Subject: Notification of Planned Change to the Permitted Facility to Support TRUPACT-III

**Notification of Planned Change to the Permitted Facility
Waste Isolation Pilot Plant**

Table Listing of TRUPACT-III required penetrations

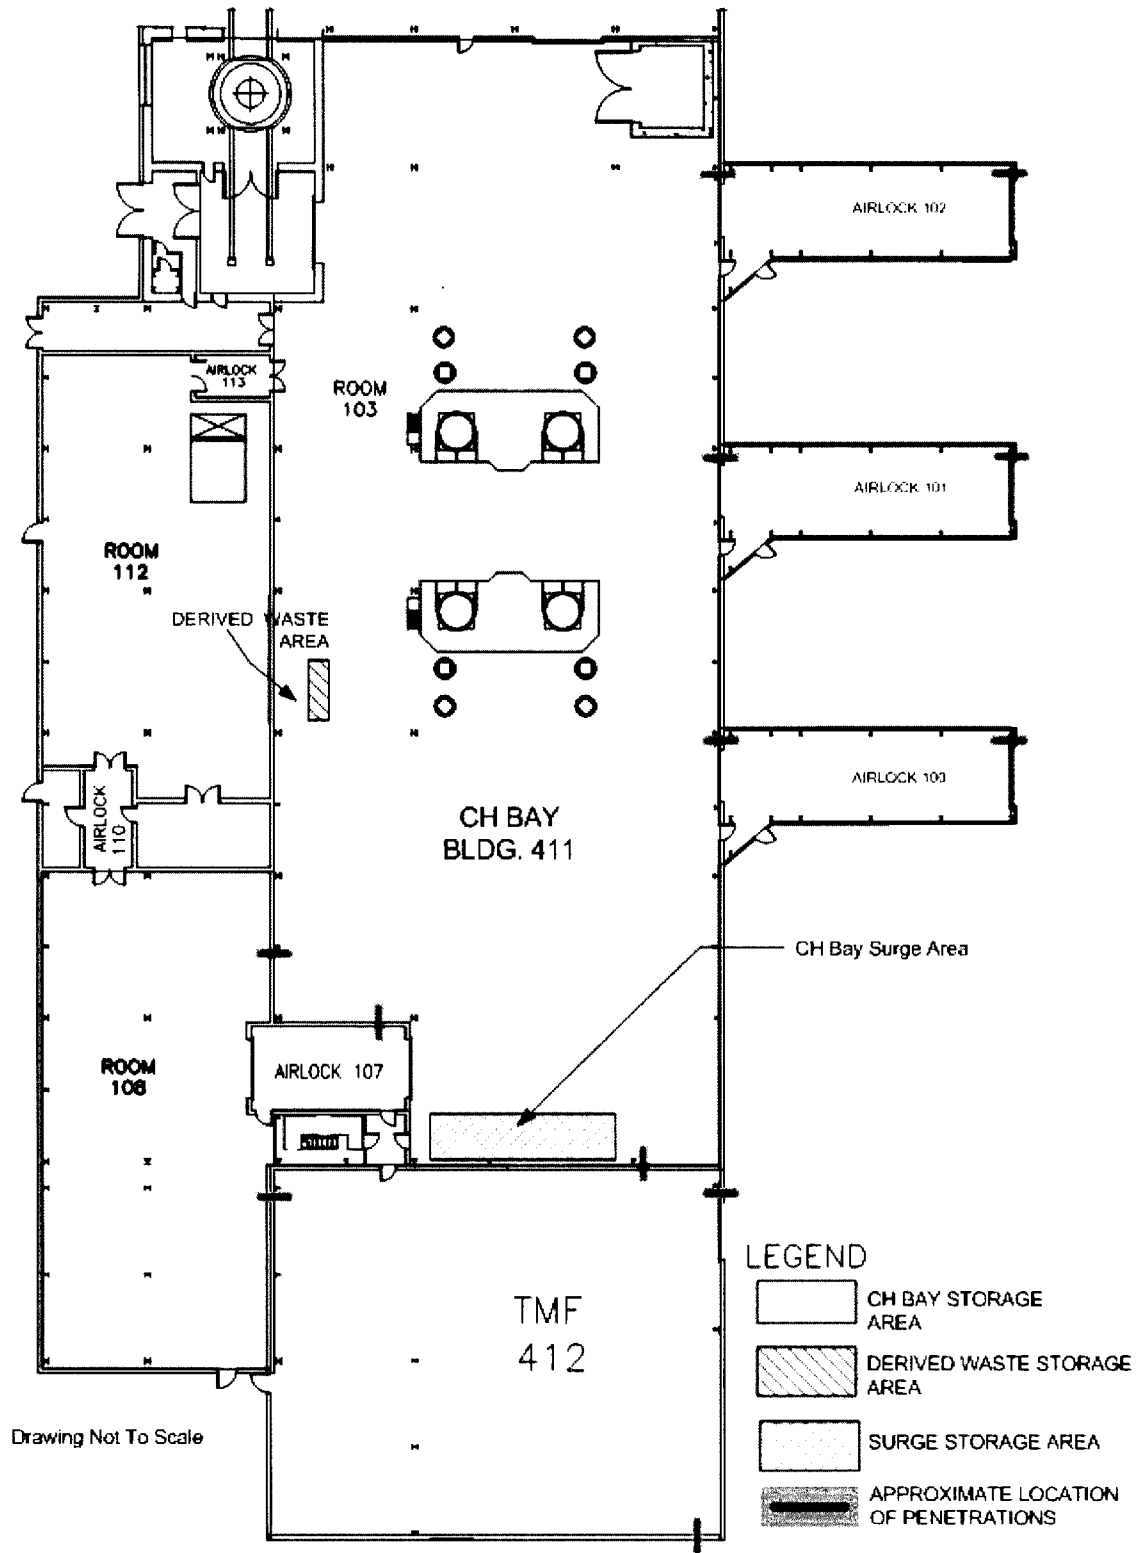
The Permittees have identified 21 wall penetrations listed in the attached table. These are needed for conduit that will be used to connect various components of the electrical, communications and monitoring systems associated with the TRUPACT-III project. The wall penetrations are for conduit access between the Contact-Handled Waste Bay (CH Bay-Building 411) and Airlocks 100, 101, 102, and 107, the TRUPACT Maintenance Facility (TMF, Building 412), and Room 108 of Building 411. The approximate locations of these penetrations are depicted on the attached figure. (Note: The figure has 12 locations for the 21 penetrations.) These penetrations will vary from approximately 1 inch to 2 ½ inches in diameter to accommodate the conduit sizes listed on the attached table. The area around the conduit will be sealed. The conduit will be capped until the wiring is installed at a later date. The capped conduit will not impact the negative pressure differential maintained in the CH Bay relative to the outside atmosphere. The work to install the 21 penetrations will occur during the 2010-2011 maintenance outage.

Some of the penetrations in the TMF are not in the Permitted Facility. These are identified on the attached table with asterisks. To fully describe all the penetrations, the Permittees have included these items in this notification for your information. In the event that additional penetrations are necessary, the Permittees will provide an additional Notification of Planned Change with appropriate details. The following table describes each penetration and its approximate size and location.

Number of Holes	Conduit Size (Inches)	Affected Area	Approximate Location
1	3/4	Airlock 102 - Outside	Adjacent to the roll-up door
1	3/4	Airlock 101 - Outside	Adjacent to the roll-up door
1	3/4	Airlock 100 - Outside	Adjacent to the roll- up door
2	3/4	CH Bay - Airlock 100	Adjacent to the interior roll-up door
2	3/4	CH Bay - Airlock 101	Adjacent to the interior roll-up door
2	3/4	CH Bay - Airlock 102	Adjacent to the interior roll- up door
3*	3/4	TMF - Outside	Adjacent to roll-up door & SW corner of TMF West Wall
2	1 1/2	CH Bay - TMF	Adjacent to the door
3	3/4	CH Bay - Room 108	East of Airlock 107 near battery charging station in CH Bay
1*	3/4	Room 108 - TMF	NE corner of TMF North Wall
3	3/4	CH Bay – Airlock 107	East wall of Airlock 107
